Technical Evaluation Report

For F-Area Tank Farm Facility,
Savannah River Site, South Carolina

Final Report

U.S. Nuclear Regulatory Commission
Office of Federal and State Materials
and Environmental Management Programs
Washington, DC 20555-0001

Figure 3-10 Tank 18 and 19 Volume Distribution Following Mantis Cleaning (SRR-CWDA-2009-00030)

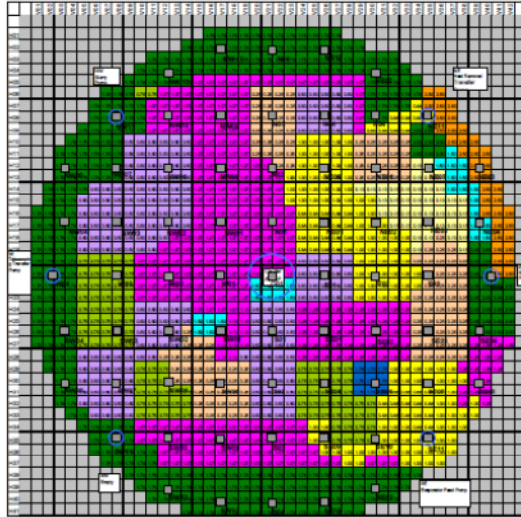
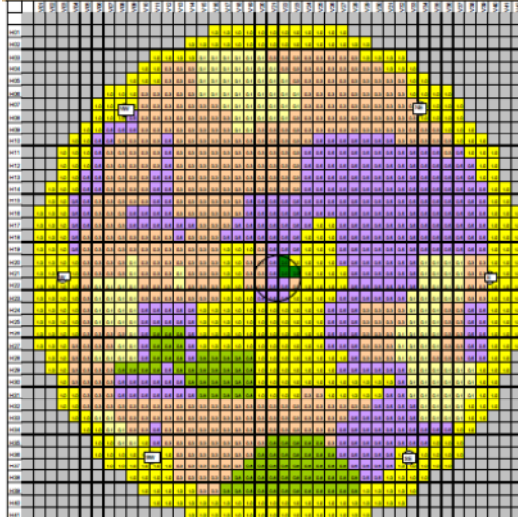
DOE does not fully evaluate the basis for differences in removal effectiveness both within each tank and between Tanks 18 and 19, and how these differences are accounted for in the determination to cease cleaning operations. As shown in Figure 3-10, there is variability in depth across the floors of each tank, and also a considerable difference in how effective the technologies were for Tank 18 in comparison to Tank 19. For example, there is a greater amount of residual material in the center of Tank 18 as well as to the northwest and south. The mound in the north region of Tank 18 that formed after the use of the ADMP may have contributed to variability prior to using the Mantis, but DOE does not describe why the Mantis may have been less effective in this area or in the southern most part of Tank 18. As discussed above, the Mantis could have been less effective in these areas due to the travel limitations that are presented in a separate reference (U-ESR-F-00041) describing the use of the Mantis in the volume mapping (see Figure 3-10), but DOE does not draw a link between Mantis travel limitations and cleaning effectiveness. Also, the difference in effectiveness of similar cleaning technologies is surprising, especially given the similarities in the tank designs and because Tank 18 was predicted to have a much lower volume of waste than Tank 19 at the end of Phase 3. Differences between the waste in Tanks 18 and 19 that may have affected waste retrieval are not clear, and in fact some descriptions indicate that waste is identical (DOE-WD-2005-002, Rev. 0) while other descriptions indicate that the waste in Tank 19 was more amenable to retrieval (e.g., V-ESR-G-0003 describes Tank 19 waste as more sand-like compared to Tank 18). The Mantis technology was first operated in Tank 19, so it would seem that lessons learned from that operation could potentially increase performance in Tank 18. Equipment malfunctions occurred during retrieval efforts in both Tank 18 and Tank 19, but the Tank 18 Mantis was operated without the forward/downward spray or the ability to tilt the crawler for some period of operation. Furthermore, the Tank 18 travel limitations may have put additional constraints on waste retrieval. DOE does not fully describe if this variability within and between tanks was anticipated. DOE does not explain why methods to improve the effectiveness of the selected technology was apparently less successful in Tank 18.

Figure 4-2 Primary Barriers Delaying Timing of Peak Dose for Four Key Radionuclides

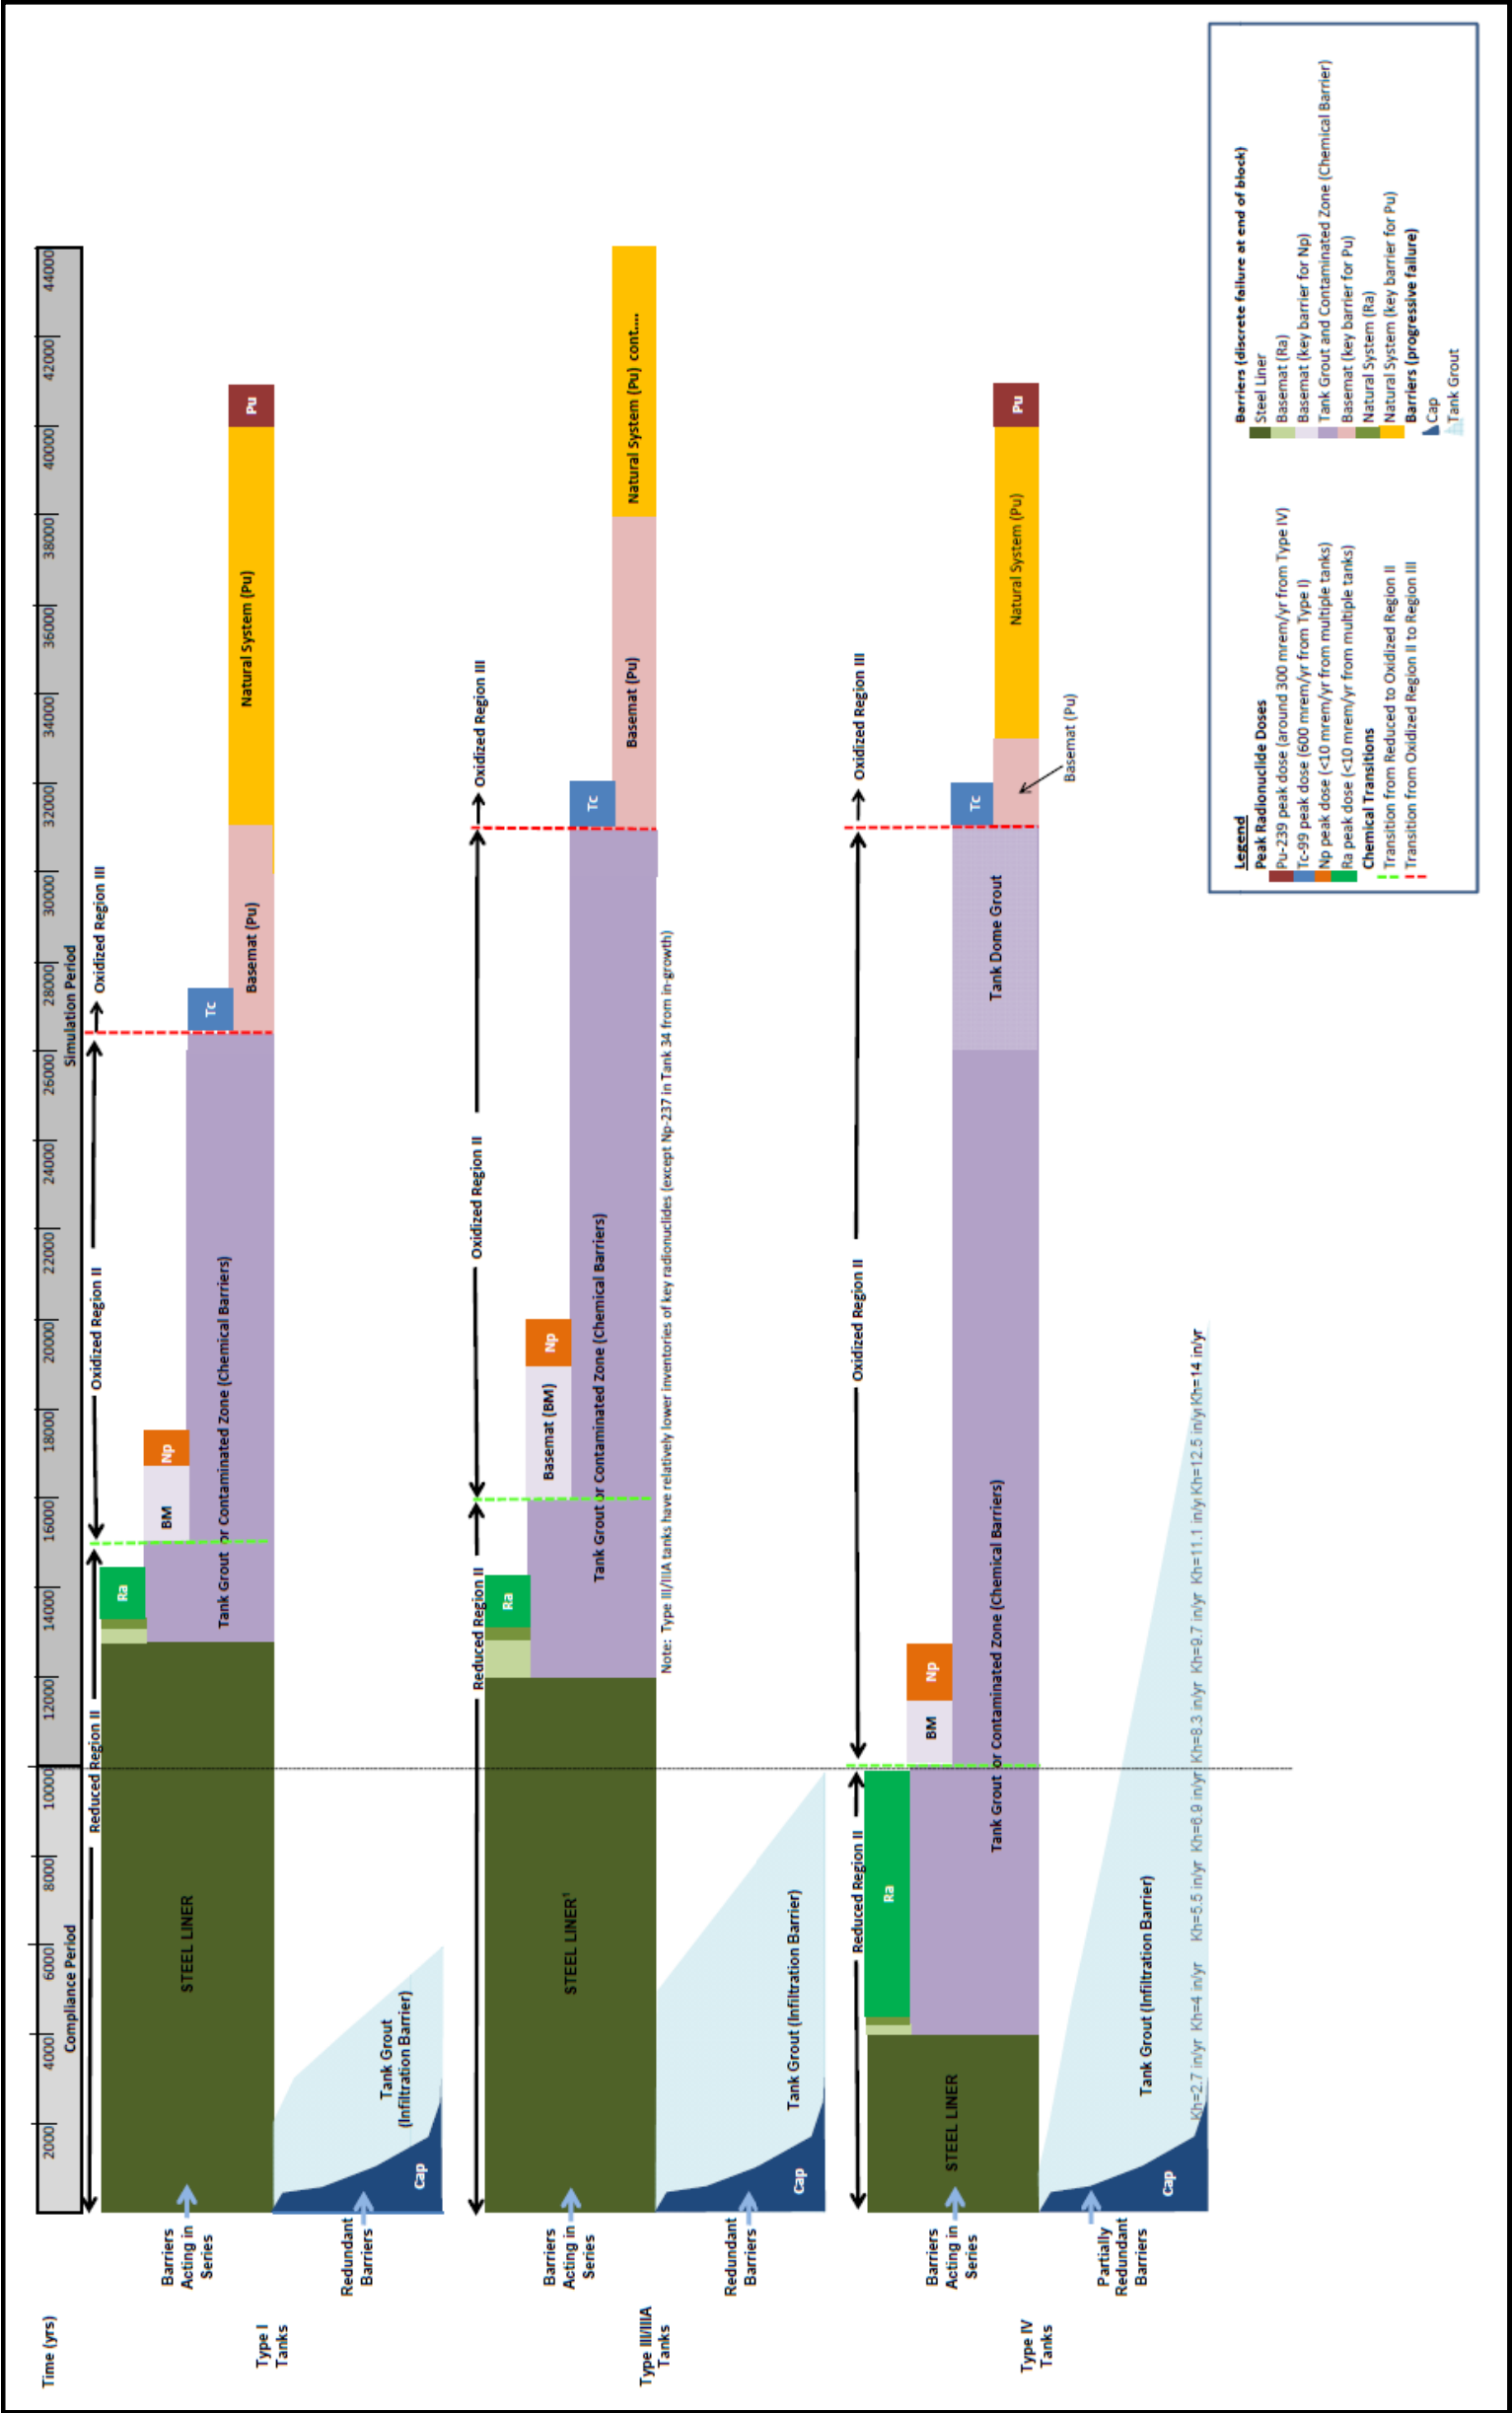
Given the rather significant differences in the times to transition to higher solubility limiting phases (see Figure 4-2) for risk-significant radionuclides such as Tc and Pu, the simulation of flow through (or around) the system including the factors listed above may be important to the compliance demonstration. NRC staff will continue to track assumptions related to chemical transition times most notably, the conceptual model for fluid flow (matrix versus fracture), progress in grout degradation modeling, and modeling assumptions that might affect flow through the system (MCC data).

Figure 4-5 Evolution of the pH of Tank Backfill Grout, Comparing Measured Column Data to Model Results

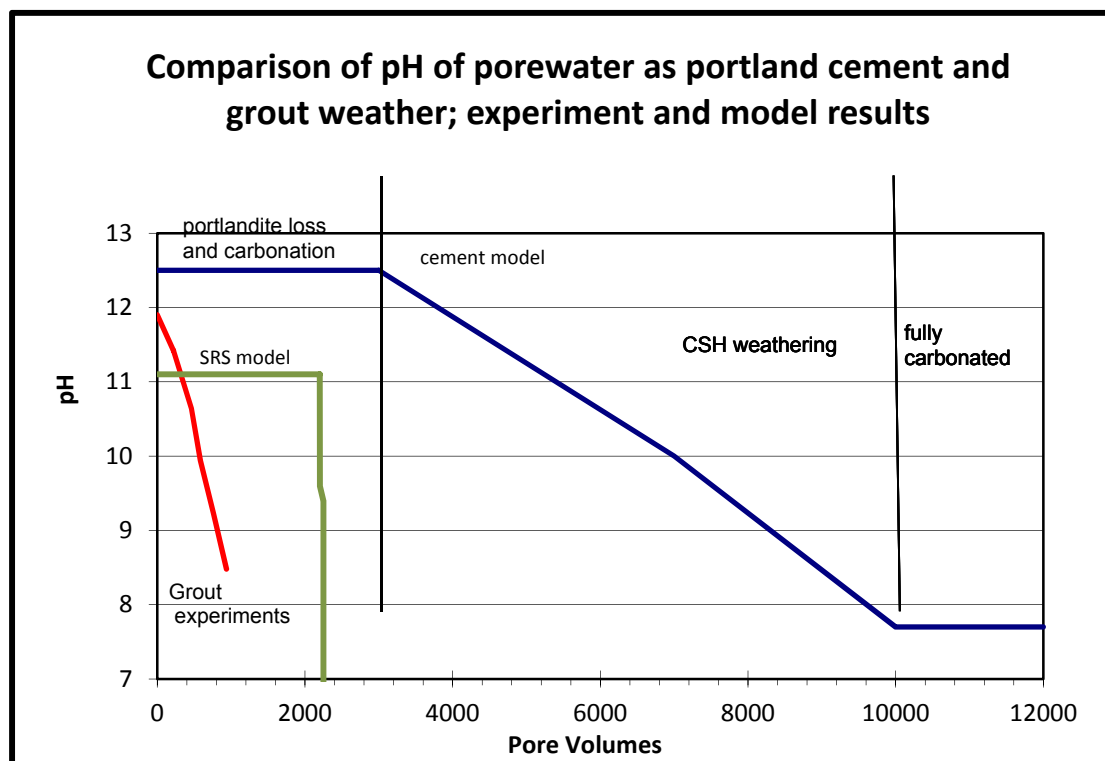
NRC staff is not convinced that a step function as used in the PA is appropriate. The experimental column data in Figure 4-5 indicates that rubblized reducing grout attains a pH of

around 8.4 in just less than 1000 pore volumes. As a result, it is extensively carbonated. While the water used was a bicarbonate groundwater (synthesized), NRC staff think that the essential trend would be similar using SRS water. The difference in behavior suggests that the basic assumptions of solid phases within the grout are erroneous. It is unclear what the chemical effects will be on radionuclide dissolution and their subsequent retention/mobilization. However, the difference in observed versus modeled pH evolution suggests that modeled redox behavior may be different as well. It will be important to provide experimental support of modeling results for a parameter as important as pH.

Given the observed changes of pH over about 1,000 pore volumes (Figure 4—5) in grouts to be used for tank backfill systems, it becomes important to understand the solubility of key radionuclides as pH changes. In turn, if geochemical modeling is used to calculate solubilities, it is necessary to know the solid phases controlling their solubility because the solubilities of

Figure 4-9 Calibrated Horizontal Hydraulic Conductivity Assignments to the Regional GSA/PORFLOW Model (Fourmile Branch is South and Upper Three Runs Creek is North of the F-Tank Farm)

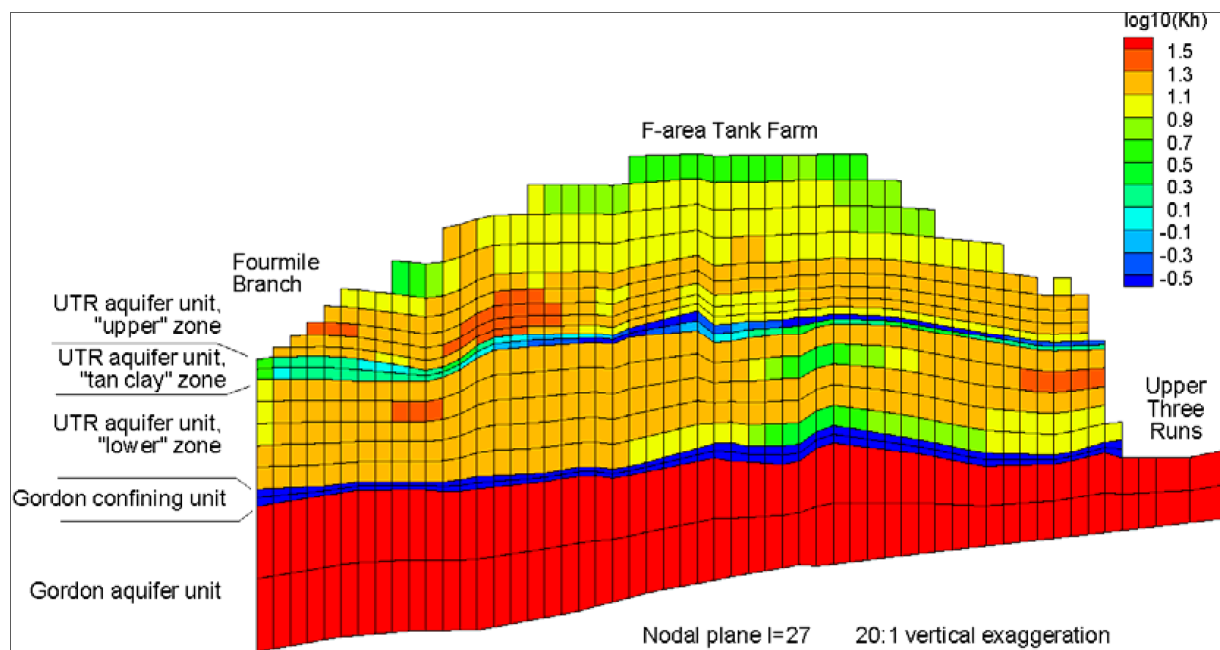
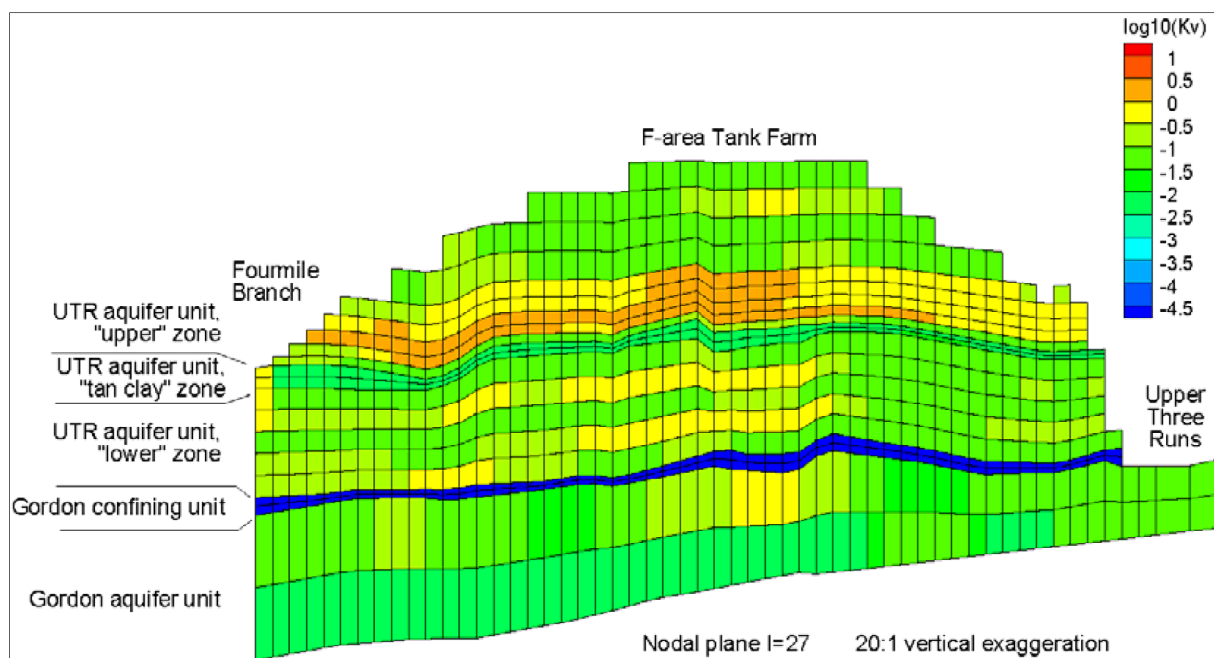
With respect to GSA/PORFLOW model calibration, the maximum hydraulic head residual in the UTR-LZ of 8.2 m (27 ft) (WSRC-TR-2004-00106) greatly exceeds the calibration goal of no more than 5 to 10 percent of the total hydraulic head variation in the UTR aquifer for the maximum head residual. The UTR-LZ exhibits large residuals where the water table drops sharply to the UTR creek and in the vicinity of H-Area (WSRC-TR-96-0399; WSRC-TR-2004-00106), but the well locations having the largest residuals are not in the vicinity of FTF (WSRC-TR-2004-00106, Figure 3-4(b)). Additional work may be needed to better define the hydraulic conductivity field in the vicinity of H-Area (WSRC-TR-96-0399; WSRC-TR-2004-00106), but relatively poor H-Area calibration should not affect the flow field and transport times from the FTF for the purposes of this PA. High residuals west and north of F-Area meet the calibration

Figure 4-12 Probabilistic Modeling Results (Peak Dose vs. Time, see July 19, 2011 RAI resolution meeting summary, ADAMS accession number ML112200656)

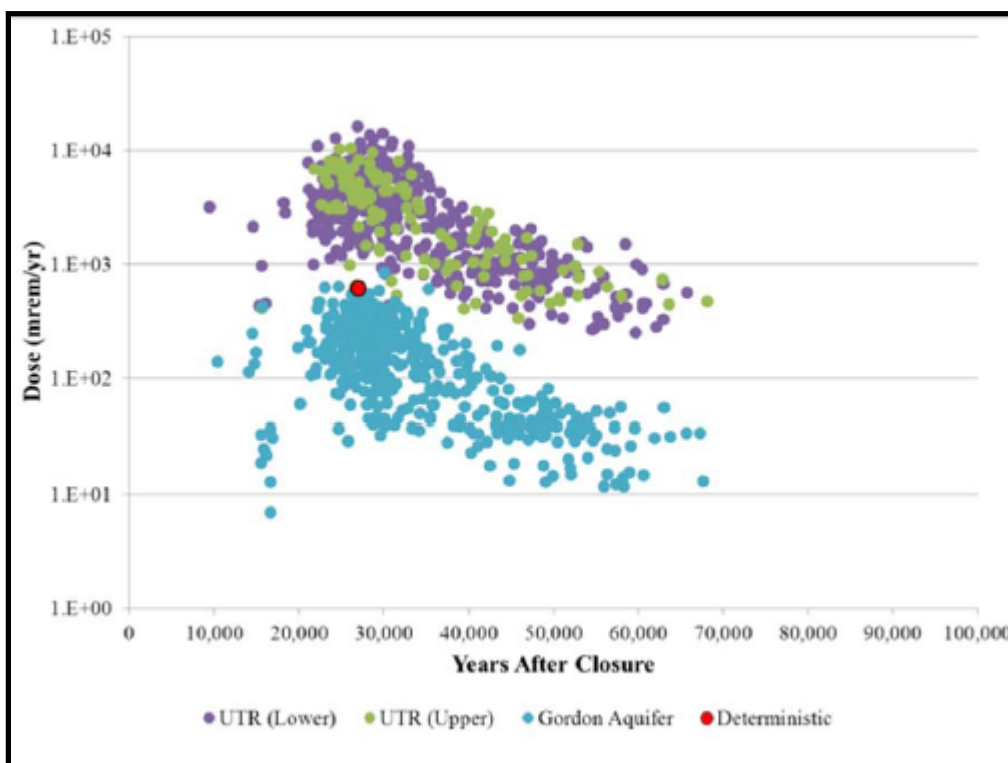
As discussed above, another important feature observed in Figure 4-12 provided by DOE following the June 28, 2011 RAI resolution meeting and discussed at the July 19, 2011 RAI resolution meeting (see Figure 1a in the attachment to the meeting summary found at ADAMS accession number ML112200656), is the appearance of two distinctly different data sets that are similar in shape and spread but only varying by roughly an order of magnitude. This result is due to a parameter assignment related to well completion. In the case of a well completed in the Gordon aquifer, DOE assumes a simple ratio between the UTR concentration and dose actually being simulated in the GoldSim and the concentration and dose in the Gordon aquifer.

The Gordon aquifer concentration and dose is not actually being calculated by GoldSim, but rather, is assumed to be a factor of 20 less than the UTR concentration. The probability of well completion in the Gordon aquifer is 40 percent. Thus, the peak doses for individual realizations depicted in Figure 4-12 occur in two distinct data sets separated by roughly a factor of 20 with realizations generally not overlapping between the two data sets over the same time intervals. Over all time, the two data sets overlap with uncertainty in the magnitude of the peak dose spanning roughly two orders of magnitude.

Figure 4-123 NRC Staff Alternative Presentation of DOE's Probabilistic Modeling Results

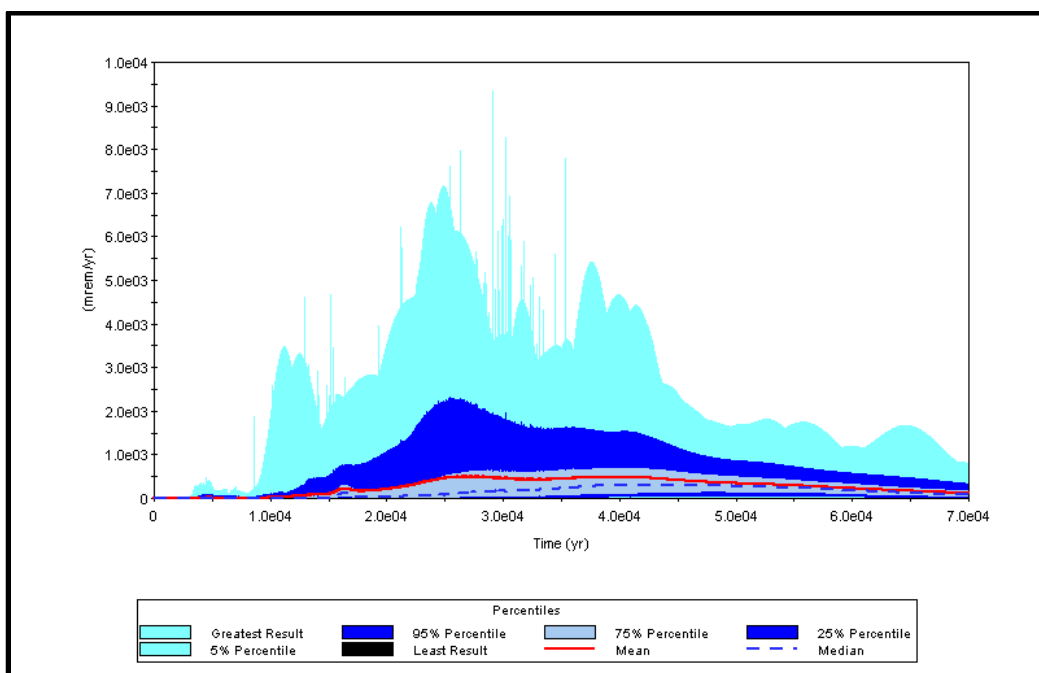
NRC staff also noted potential inaccuracies in the statistical information being presented in the PA due to the selection of a 1,000 year averaging time for plots in the probabilistic assessment. Furthermore, compliance with the performance objective in 10 CFR 61.41 should be against only those realizations with a well assumed to be completed in the UTR (and not the Gordon aquifer) as discussed in the July 21, 2011 RAI resolution meeting (ADAMS accession number ML112070958). Figure 5.6-38 in the PA (SRS-REG-2007-00002, Rev. 1) was replaced with another figure that considered (i) only those wells completed in the UTR, and (ii) used a plot time of 10 (rather than 1000 years). Figure 4-13 below shows NRC's attempt to provide more appropriate figure to assess compliance as an alternative to the one presented in DOE's PA Figure 5.6-38 (page 625 of SRS-REG-2007-00002, Rev. 1). The results shown in Figure 4-13 indicate a peak of the mean dose of around 0.20 mSv/yr (20 mrem/yr) over a 10,000 year period of performance and an overall peak of the mean dose of 5 mSv/yr (or 500 mrem/yr).
